# CITY OF ALBUQUERQUE

RE: Backyard Biergarden 1320 2<sup>nd</sup> St NW

Grading and Drainage Plan Stamp Date: 4/26/19

**Hydrology File: J14D046**

**GRADING & DRAINAGE PLAN**

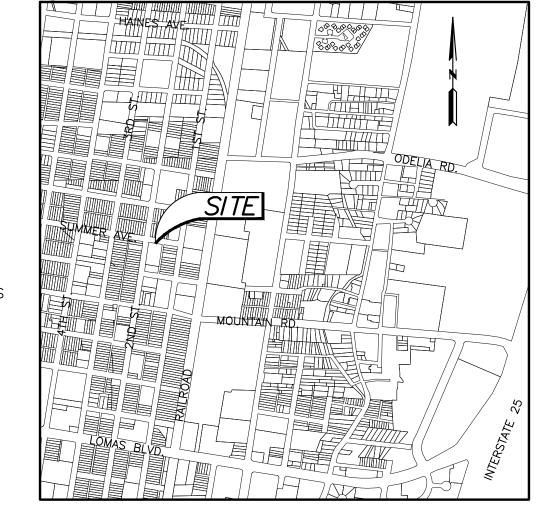
1. This site qualifies as redevelopment and is only required to retain runoff from the 80<sup>th</sup> percentile storm (Volume = 0.26"\*Imp.Area).

2. The storm water quality (SWQ) retention facilities (pond, cisterns, etc.) need to be sized for the area draining to them. Locating the pervious parking lot on the uphill side of the project does not meet the storage requirement as no impervious area will drain to it. Runoff from all impervious area must be captured.

- 3. Alternatively, payment in lieu of onsite retention may be accepted for areas bypassing the SWQ facilities. In order to pursue this, the plan must state that: you could provide onsite management, you do not want to (due to cost or convenience), and you are electing to make the Payment in Lieu of onsite management. A treasury deposit slip can then be generated for the bypass volume at a rate of \$8/cf of bypass.

- 5. Has the TCL been reviewed by Transportation? They will likely require the extra driveways on  $2^{nd}$  St be closed, meaning sidewalk culverts or drain lines through the curb will be required to discharge any runoff to  $2^{nd}$  St.

- 6. If sidewalk culverts or drain lines are required, they may be built by SO-19 Permit (assuming there is Work Order associated with this project). If an SO-19 Permit is required, it should be included on the request. Please include the standard SO-19 notes on the grading plan.

- 7. Only one paper copy of the submittal is required.
- 8. Increase the density of proposed spot elevations, especially along the property lines. Per the DPM Ch 22.7 Grading Plan Checklist, for flat sites supplemental spot elevations are required to adequately illustrate the proposed grading of the site.

- 9. For trash enclosures serving food service developments, demonstrate *control of liquids from* dumpster areas per DPM Chapter 22.9.E, Table 1 by containing runoff from the dumpster area and discharging to the sanitary sewer. If this information is on the utility plan please provide it, or show on the grading plan.

- 10. Include project benchmark and datum.
